Administrative Approval Action

Case File / Name: ASR-SR-78-2018
DSLCL - Skycrest Crossing Apartments

REQUEST: This is a SUNSET REVISION for a previously approved site plan (prior sunset date of 2/09/24 with a letter requesting extension received on 7/26/23) incorporating revisions to the previously approved right of way and utilities. The proposal is for a 17,766 square foot two story apartment building consisting of 14 units and associated infrastructure. In accordance with UDO Section 10.2.8 F the new sunset date will be 7/26/25.

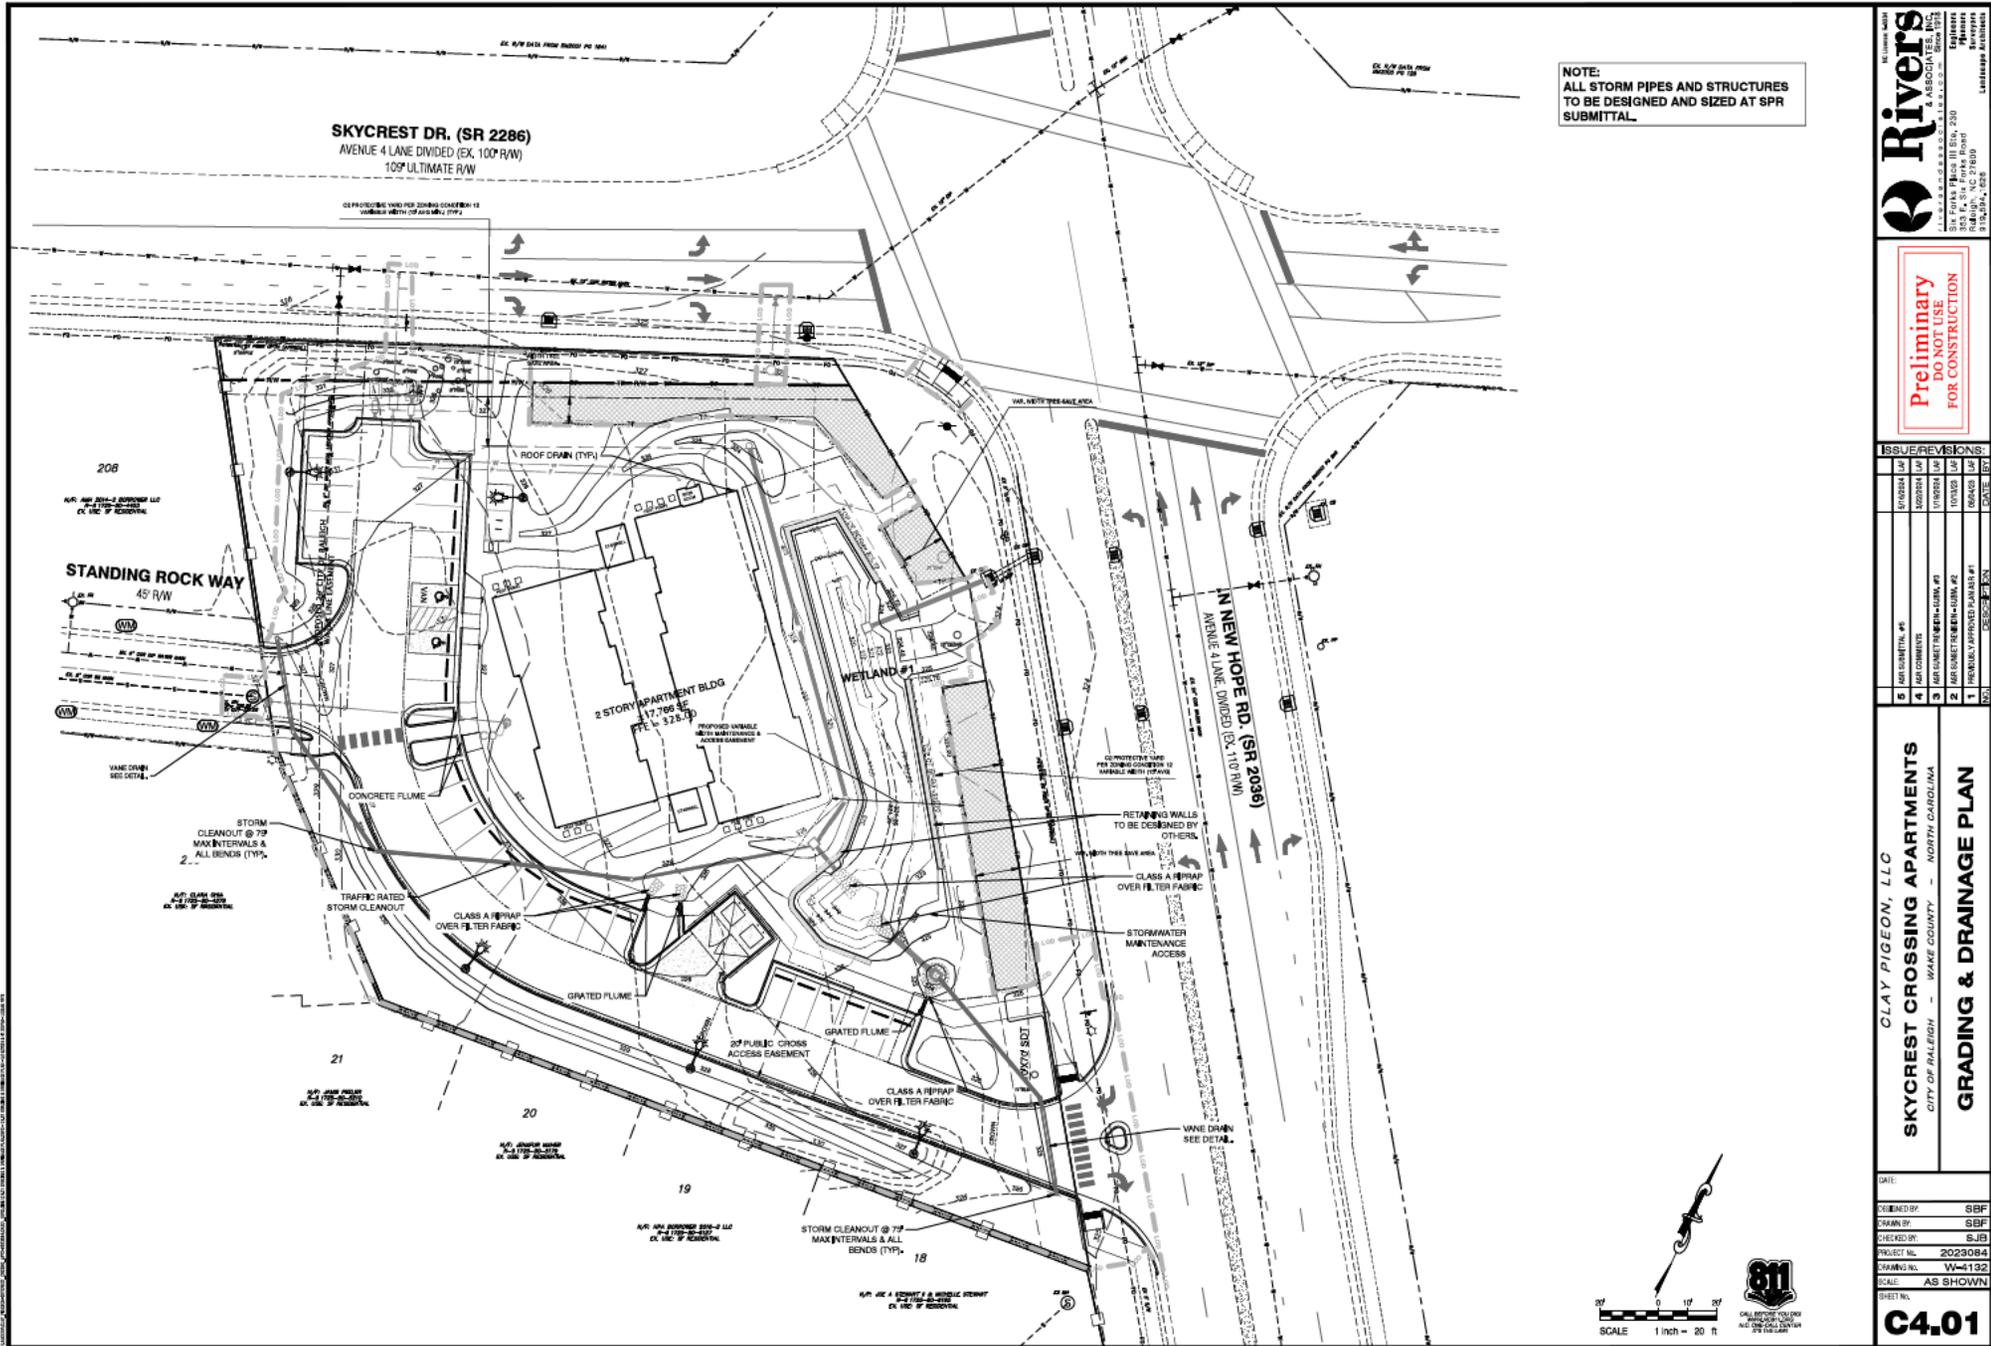
The plan does not fully show the 5' Utility Placement Easement below the driveway. The 5' UPE is to be across the entirety of the frontage including the driveway.

The cross access easement is to be labeled as such on the plan.

SHEET
SE1

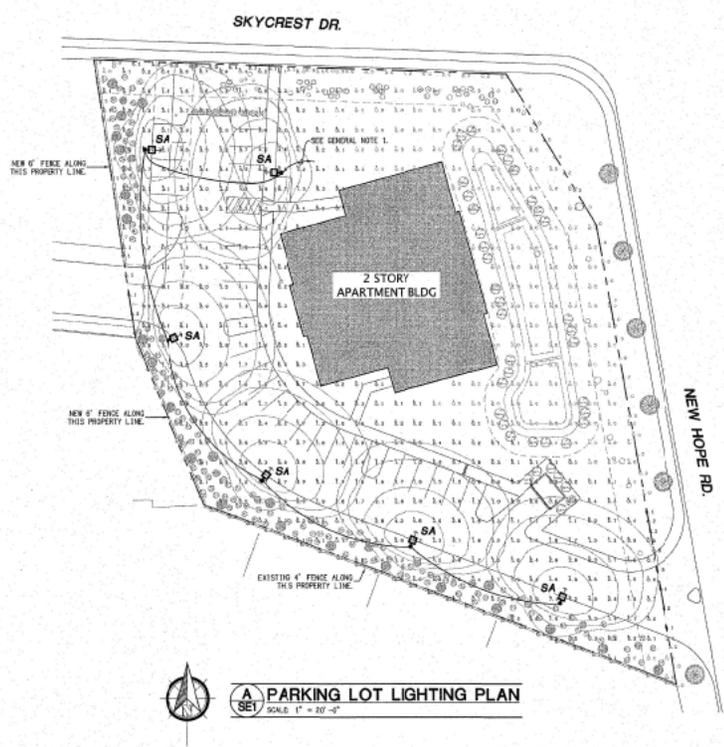
2. That the lighting plan will provide detail of lighting pole height demonstrating compliance to Z-26-97, #3.
3. Upon submittal of the new/revised SPR, please include the revised AA, and the revised plan set (Sunset Extension and Revision) in the SPR packet.
4. Cover sheet - For clarification please add a response to each of the 12 zoning conditions (Z-26-97) explaining how this plan meets each condition.

- LIGHTING FIXTURE SCHEDULE NOTES:**
1. HEIGHT OF TOP OF FIXTURE TO BE 10' ABOVE SURROUNDING GRADE PER UNIFIED DEVELOPMENT ORDINANCE (UDO). VERIFY FINISH COLOR WITH OWNER. PROVIDE STRAIGHT, ROUND, ALUMINUM POLE. SELECTION OF POLE CROSS SECTION WILL BE SUBJECT TO WIND LOAD RATING OF SITE LOCATION. COORDINATE WITH SUPPLIER.
2. FIELD SET THE LIGHT DISTRIBUTION OF PARKING AREA LIGHT FIXTURES. ARROWS ON FIXTURE SYMBOLS REPRESENT DIRECTION OF OPTIC THROU.
3. PROFILE PAGES AT FIXTURES.
